CHAPTER 9 Responses to Comments on Chapter 7

Table 9-1
List of Commenters on the Recirculated Draft PEIR

Chapter 7 and Recirculated Sections of the Draft Program Environmental Impact Report, City of Lake Forest Opportunities Study General Plan Amendment and Zone Change, Orange County, State Clearinghouse No. 2004071039

Figure 1
ADT VOLUME DIFFERENCES
- EXISTING-PI-US-PROJECT

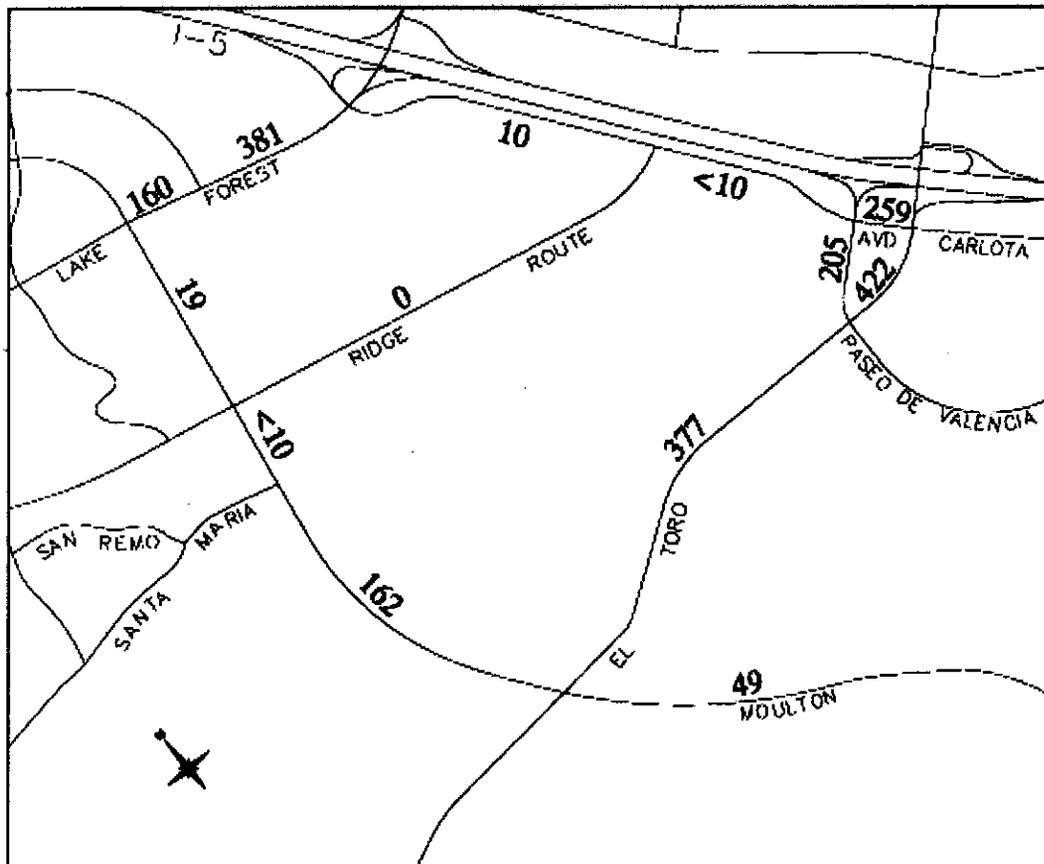
The attached diagram shows the difference in ADT volumes between existing and existing-plus-project. It illustrates the finding that with the above exception, no impacts occur south of I-5.

RTC 5-48 The analysis contained in the DPEIR and RDPEIR is program-level and is necessarily a long-term analysis as the buildout dates of the various site-specific developments within the Opportunities Study area is unknown at this time. Project-level environmental review will be prepared for individual development proposals at the time applications are submitted to the City. Should additional intersection impacts be identified at that time, mitigation will be included.
